STAFF REPORT: JULY 8, 2020 MEETING

APPLICATION NUMBER: 19-6733

ADDRESS: 677 W. CANFIELD

SCOPE OF WORK: REHAB BUILDING, REPLACE SIDING AND TRIM, REBUILD FRONT PORCH

Front Elevation (6 of 16):

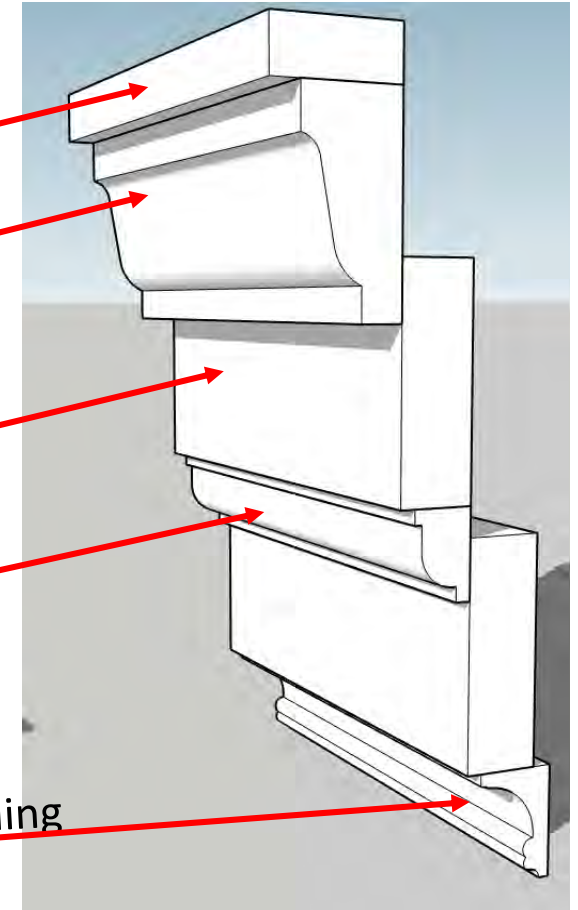
Gable Trim Replacement: This application proposes to replace the molding on all four (4) gable elevations. It is not clear to staff that all four elevations require full replacement. In areas such as the rear elevation gable, deterioration is clear and therefore replacement may be warranted. However, staff is concerned that a full replacement of all original trim on the home is excessive and does not fully explore all options for repair. Staff recommends that only the gable trim that has deteriorated beyond repair be replaced and all other trim be repaired in-kind.

Front Elevation (7 of 16) – Siding:

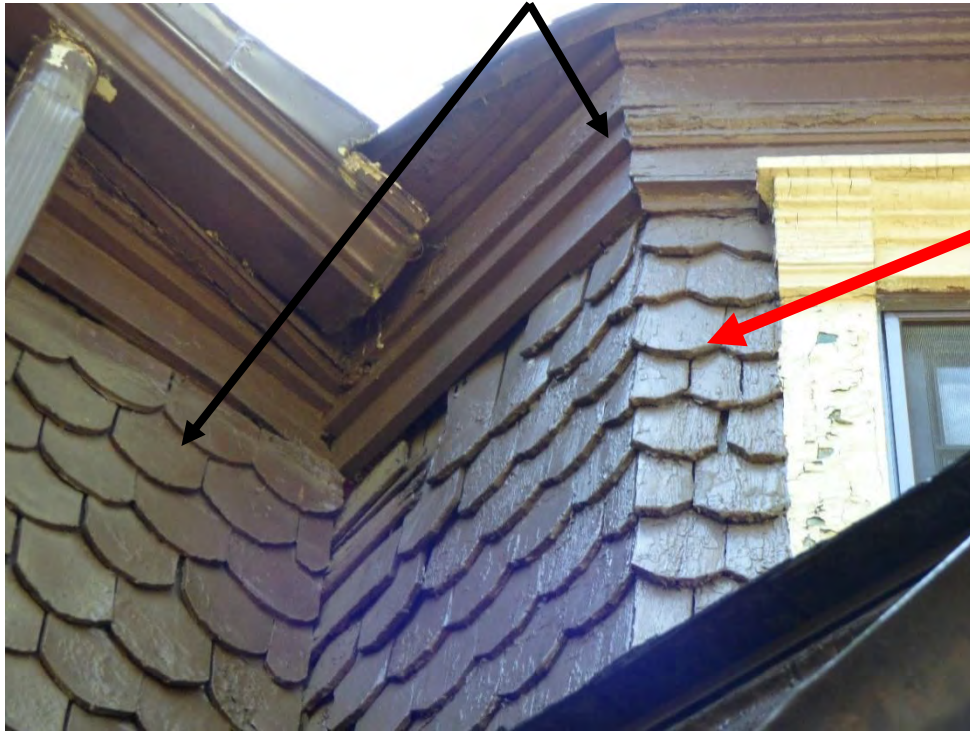
Siding Replacement: Staff has concerns about the replacement of all of the scalloped siding with Hardie panel. One of the features that make wood shake siding a character defining architectural feature is that deteriorated areas can be replaced as needed without requiring a full replacement. Staff also has concerns that the size of the proposed Hardi siding does not come close enough to replicating the existing dimensions in width (existing wood siding: 4" wide, 5" reveal, .375" thick; proposed siding: 6.75" wide, 5" reveal, .25" thick). Additionally, staff has concerns about how hardi-board siding can be installed while achieving mitered corners and flared areas as it is a rigid product. The applicant has provided information that lists general installation requirements, but the provided information does not address these concerns. Therefore, it is staff's opinion that areas of the shake siding should be repaired in-kind with new wood shingles.

Front Elevation (9 of 16) – Window Surrounds:

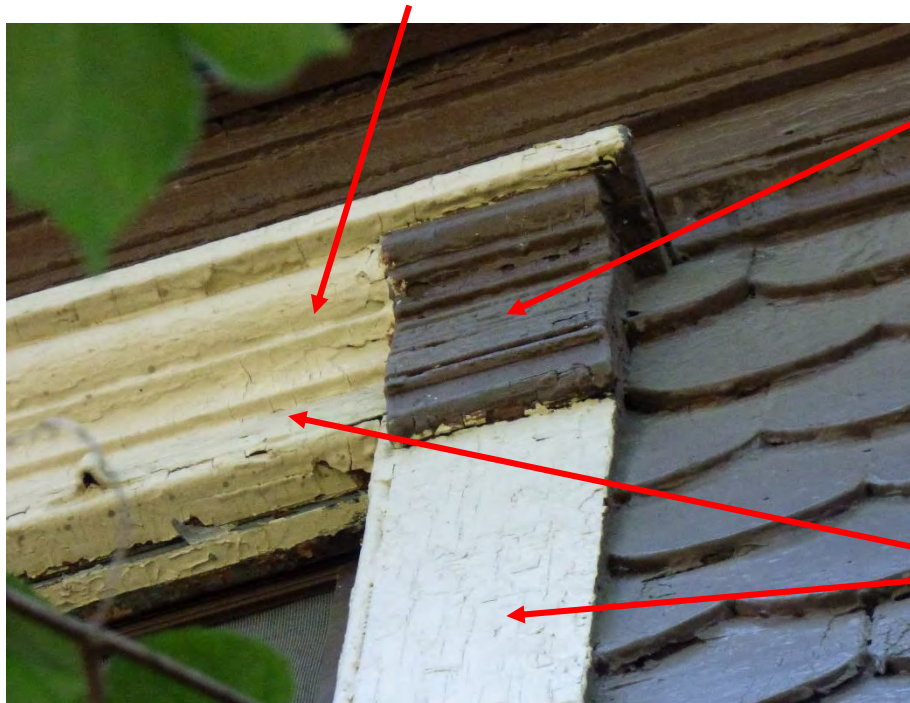
Window Trim Replacement: As with the gable trim, is not clear to staff that all areas of window trim require full replacement.

Front Elevation (15 of 16) – Front Porch:

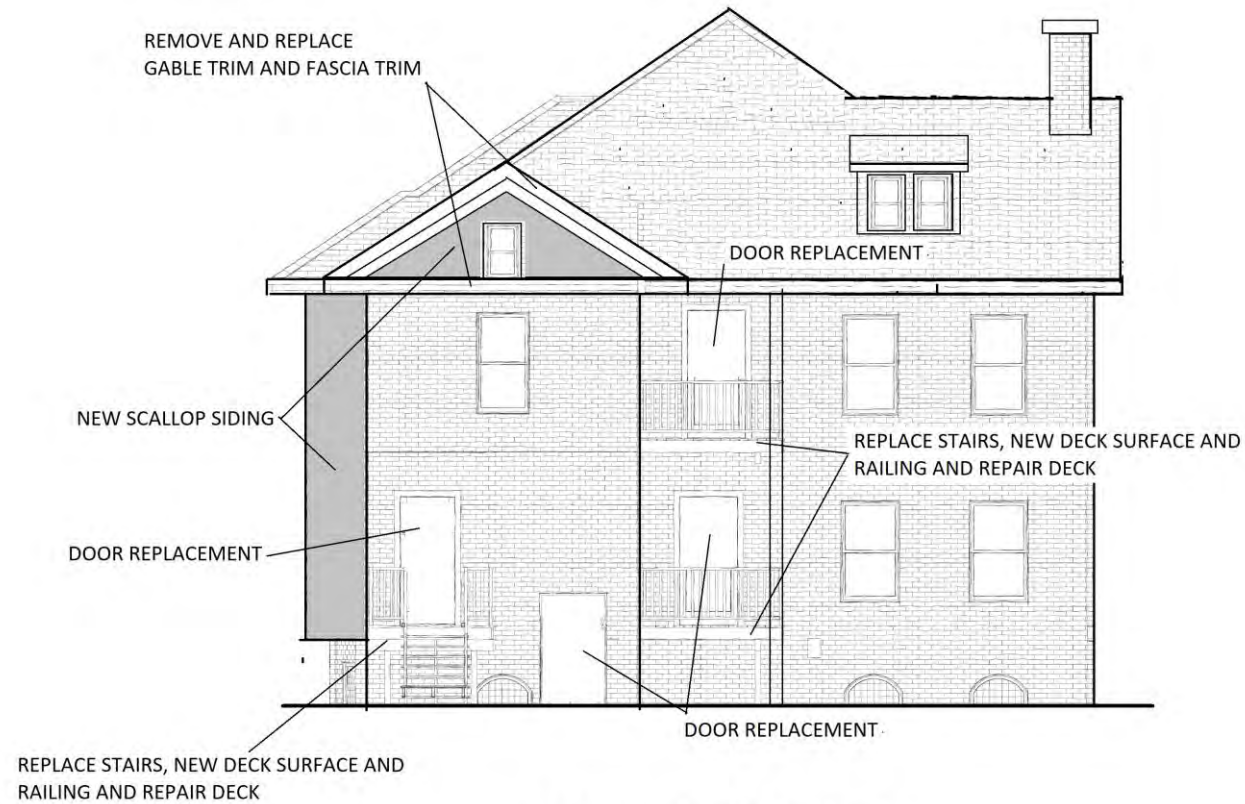
Porch Column Replacement / Repair: The application does not indicate specifically what porch columns are repairable and what columns will be replaced. Staff would request that the applicant detail what columns and what elements of the columns will be repaired and what will be replaced.
